**CHARTER TOWNSHIP OF VAN BUREN
PLANNING COMMISSION AGENDA
Wednesday, June 22nd, 2022 – 5:30 PM
Van Buren Township Hall
46425 Tyler Road**

TO:	Van Buren Township Planning Commission
FROM:	Dan Power– Director of Planning and Economic Development
RE:	Draft Sumpter Road Corridor Plan
DATE:	June 16, 2022

TO: Van Buren Township Planning Commission
FROM: Dan Power– Director of Planning and Economic Development
RE: Sumpter Road Mixed Use Zoning District and Sumpter Road
Overlay District: Update
DATE: June 16, 2022

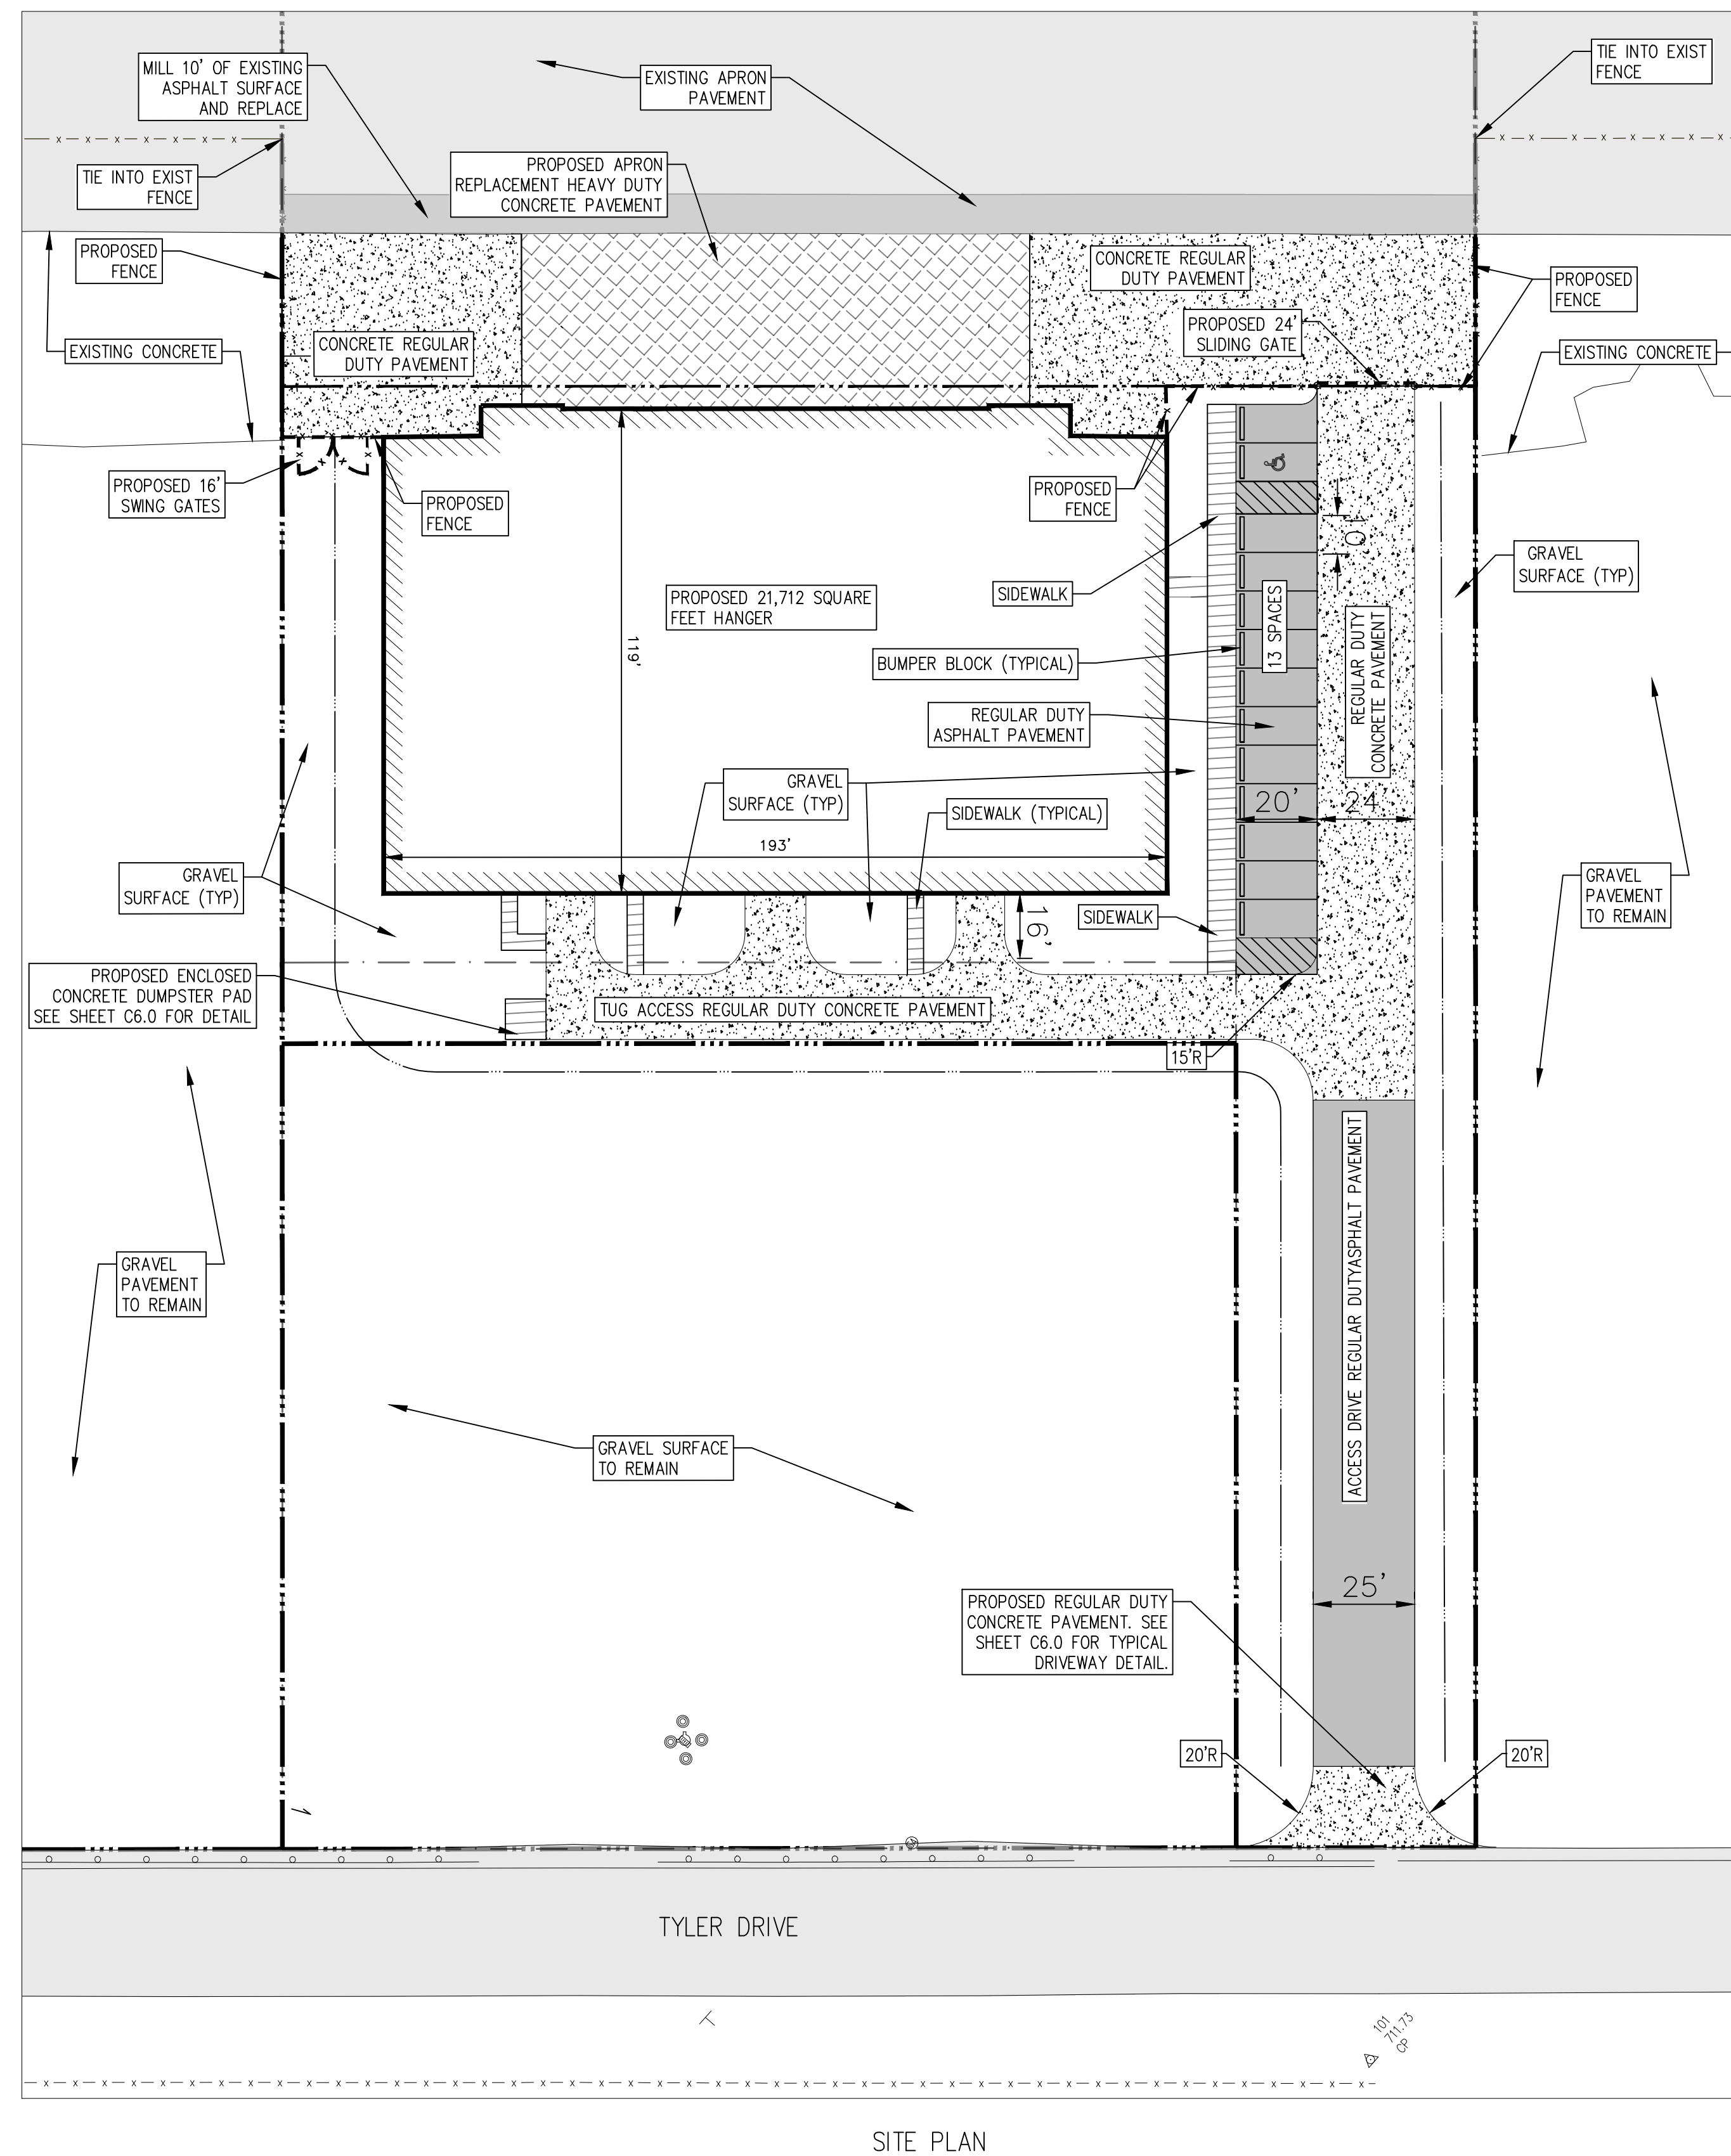
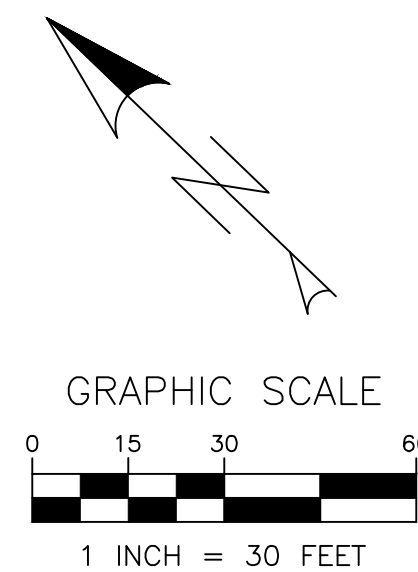
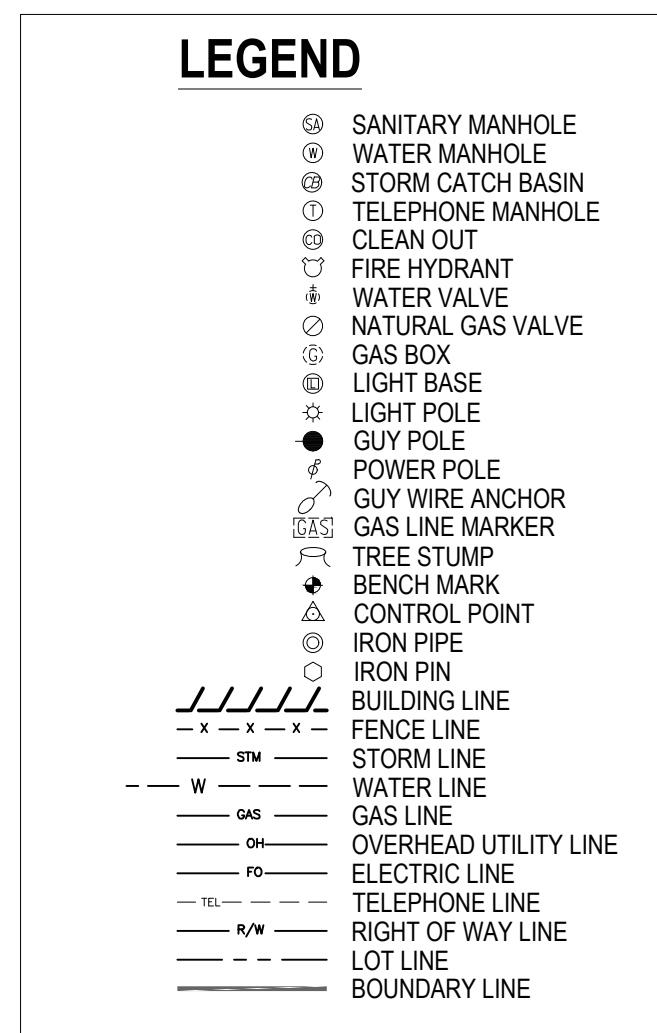
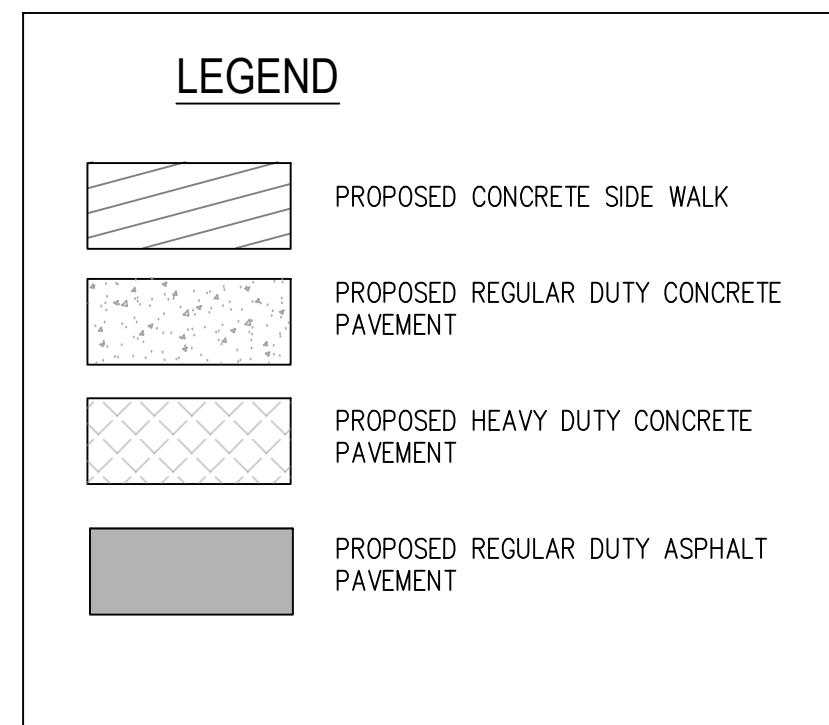
- There is a discrepancy between the area of the building stated on the plan drawing on sheet 3.0 (20,244-sq. ft.) and in the site data notes on the same sheet (21,712-sq. ft.). This discrepancy must be clarified.
- The applicant must gain Wayne County Airport Authority (WCAA) and Wayne County Department of Public Services (WCDPS) approval for their proposed stormwater design.
- The applicant shall secure approval from the Willow Run Airport Authority Fire Marshall for the proposed access design.
